HERITAGE VAUGHAN COMMITTEE JULY 17, 2013

1. 1 CLADDAMOUR PLACE – PROPOSED NEW CONSTRUCTION – WARD 2

To consider the background and analysis portion of this report in order to review the proposal for a new single family home at the subject property.

Proposed Site Plan

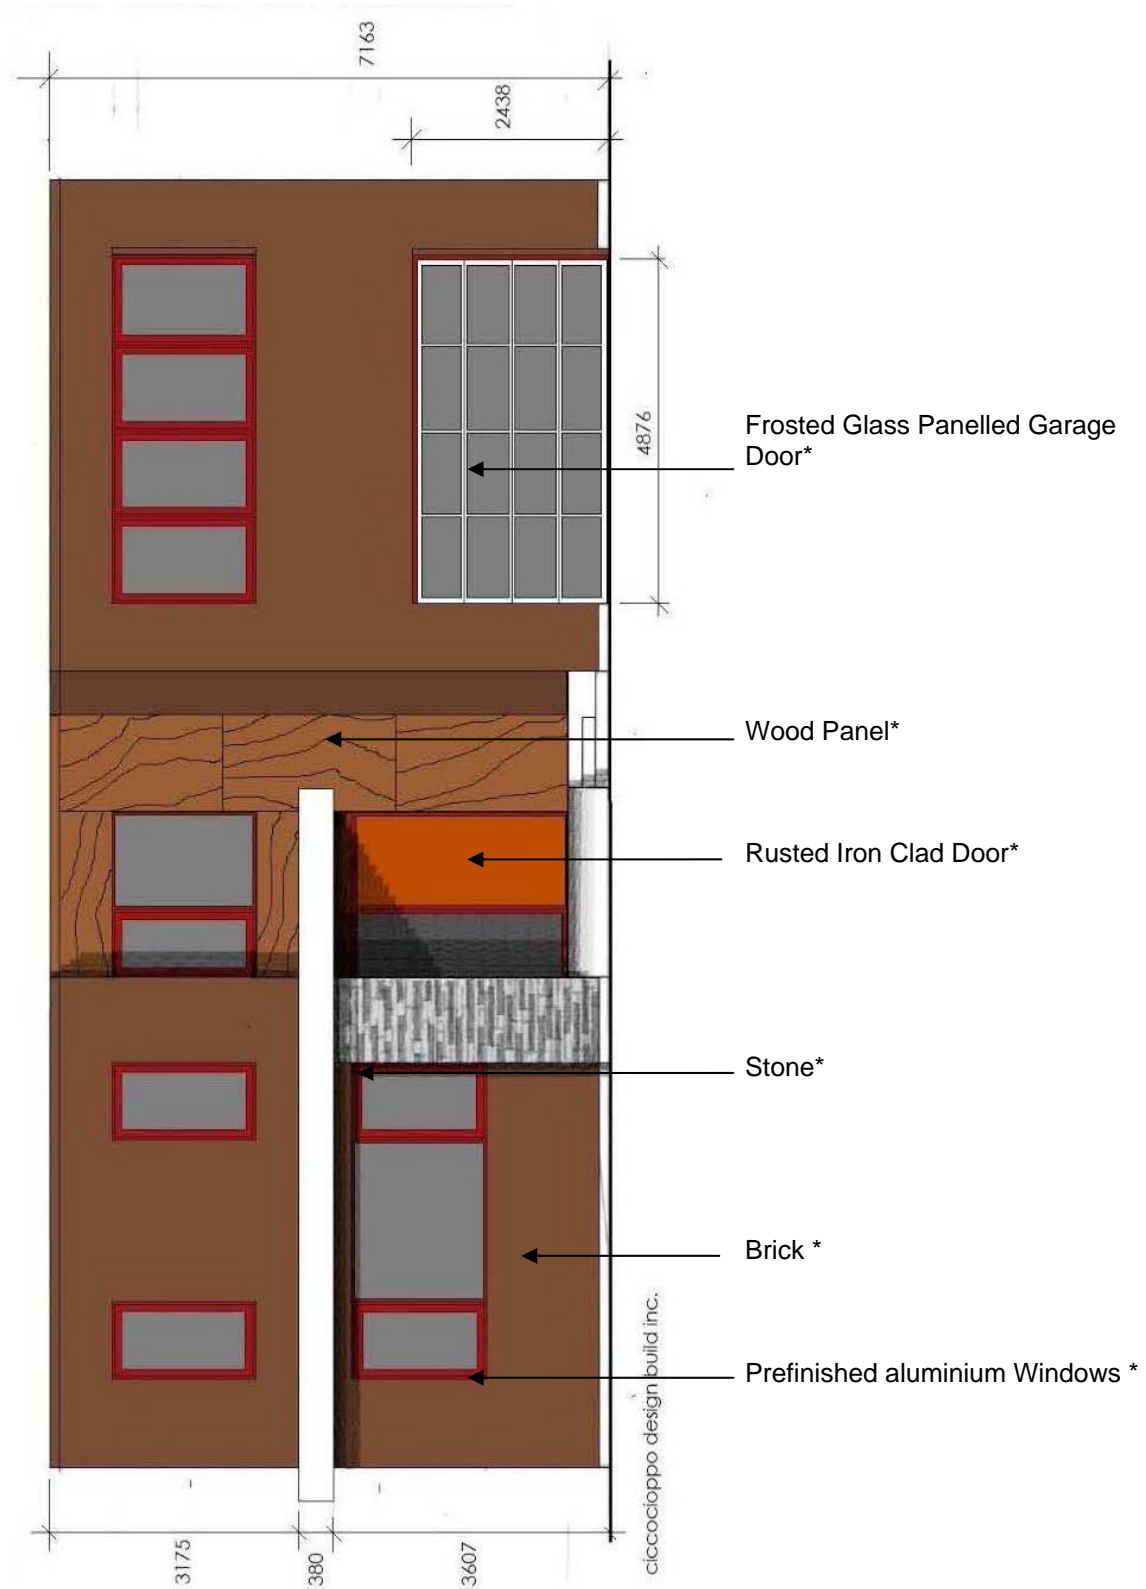
The applicant has explained that the building's *form* is a direct response to the shape of the buildable area in the lot, resulting from allowable setbacks. The form is generated from an analysis in plan resulting in a “collision of two geometric cubes conforming to the shape of the land boundaries. The two cubes are fused together by a third cube... connecting the interior space both horizontally via passage ways and vertically to lower and upper levels... The building is connected to Claddamour Place by the gentle slope of a ramp from the front door to the road. This ramp also slopes down towards Clarence Street to a gathering space. This is an attempt to associate and connect the formal entry from Claddamour to the Clarence Street side”. The canopy leading to the front door on Claddamour continues as a fascia line and wraps around to the elevation on Clarence, in an interpretation of a wraparound verandah.

The site plan is useful to understand the basis for the form of the design as two blocks coming together with a resulting and connecting middle geometry as described as well by the applicant/architect. The geometry is derived from the identification of the simple geometries that fit within the shape of the corner lot and its allowable setbacks. Each simple rectangular shape in plan shares characteristics with the straightforward geometries in plan exhibited by traditional homes of the 19th century such as Georgian or Victorian. Even though the shapes are arranged in a more contemporary way, there is potential to develop a sympathetic contemporary design within the District.

Concept A: North Elevation (facing Claddamour) - * all materials will require review of samples for approval

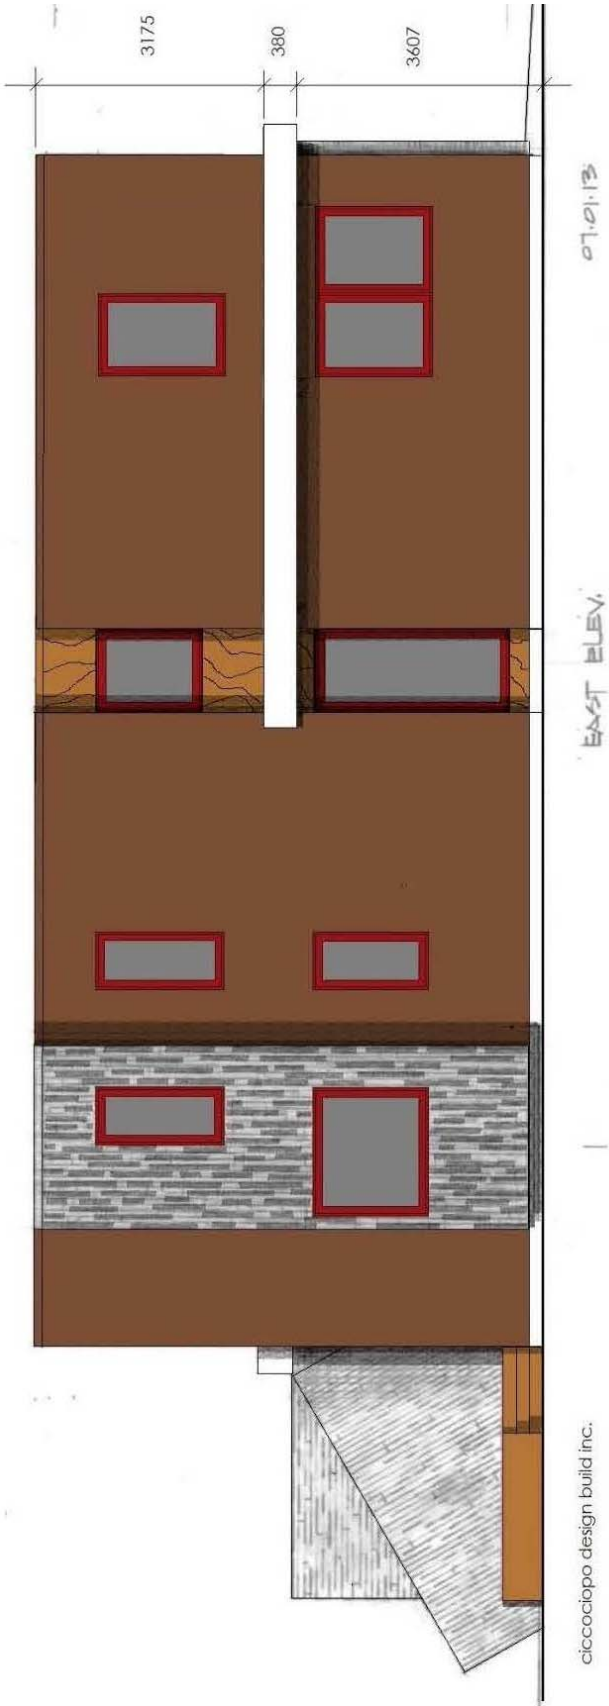
The composition of the Claddamour façade, which is officially the front of the building, works with a subtle play of symmetry reflected in the relationship of solid to void elements in the arrangement of the window panes and alignment of windows and garage door.

The block on the left and the block on the right are discernible and are consistent with the rationale for the design in plan shown in the site plan. The form of the link portion on the second floor is clearly discernible in form and distinct cladding material that has been assigned to it (two blocks fused together). The link would be flush at roof with the adjacent blocks. The module represented in the single rectangular window pane follows a close proportion to a traditional 1 to 2 vertical proportion. This module idea, sometimes adjusted to fit within other important compositional lines, is used to make the different window compositions. Using a vertical window proportion connects with the traditional notion of a window.

The natural stone clad wall reaches out to the front yard and continues through the house and out to the back yard. The design also introduces a cantilevered flat front porch roof. The fascia line of the roof continues to wrap around to the Clarence Street façade, as a nod to the wrap around porch concept. The feature takes advantage of the corner lot to make this a visible feature.

The Garage door material will be frosted glass, following the rhythm of solid to transparent established by the composition of the windows on the same elevation.

- a. That the applicant work with staff to finalize the design for the south and west elevations of the design following the concepts depicted in the attached north and east elevations; and,

- c. That the applicant submit material samples for review and approval by Cultural Services staff when these are available; and,
 - d. That the applicant submit two copies of a finalized set of architectural permit drawings for review and approval by Cultural Services staff, including site plan, plans elevations; and,

Concept A: East Elevation (facing Clarence Street)

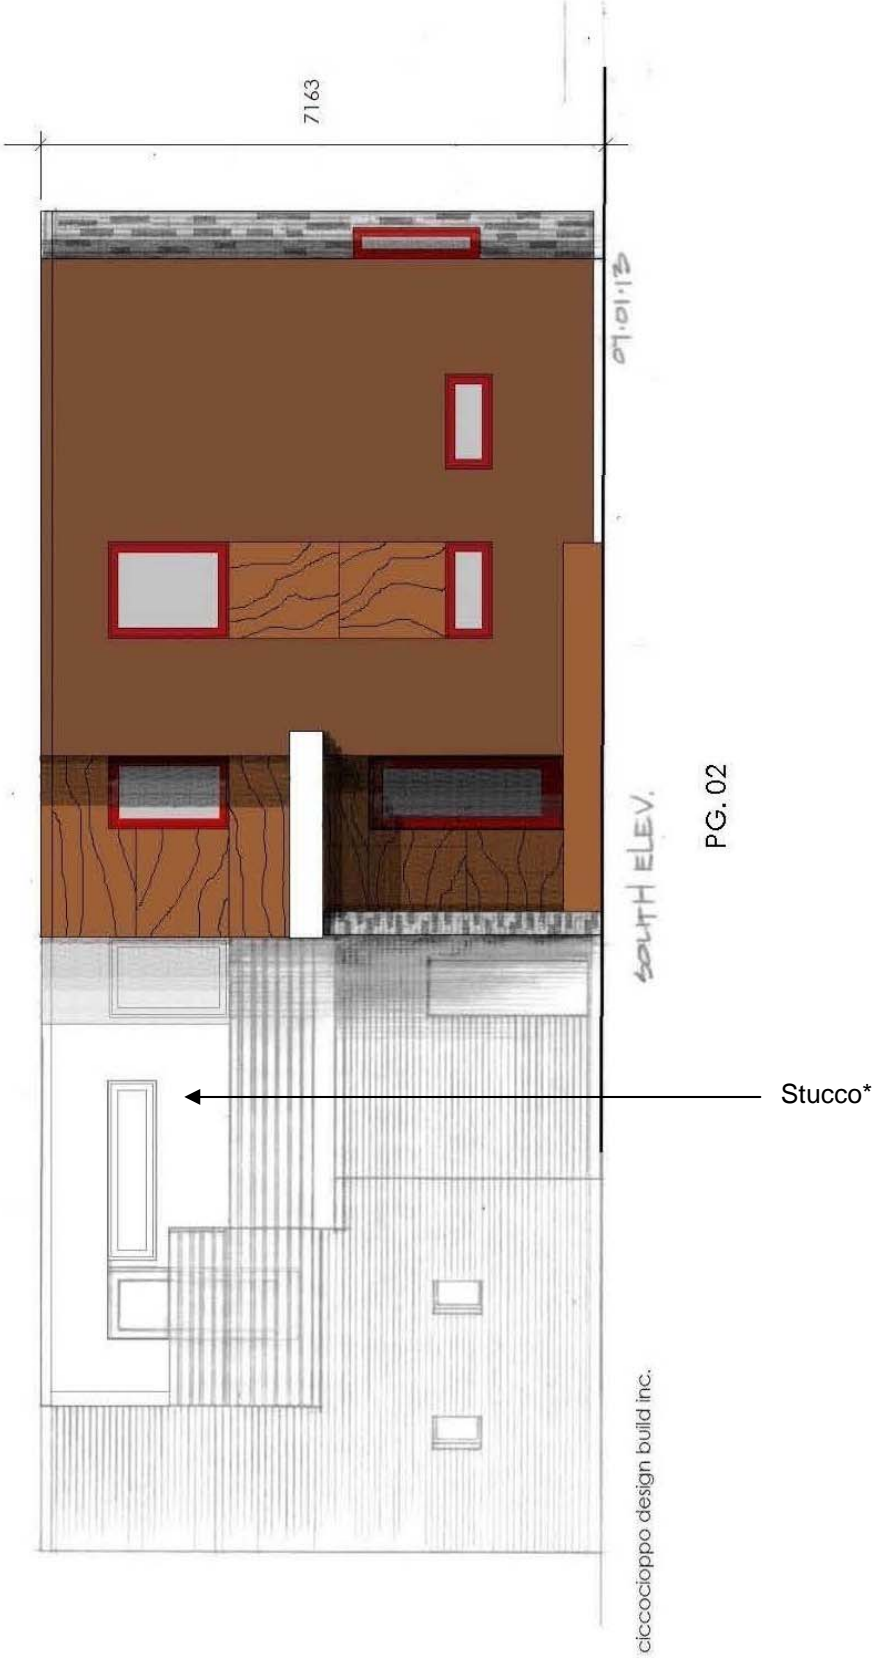
The Clarence Street elevation has been greatly simplified to articulate one main block in dark and the use punched windows of vertical proportion.

The projecting two storey window bay adds interest to the composition, using a natural stone for the cladding making a link to the continuation of the stone wall visible from the Claddamour façade.
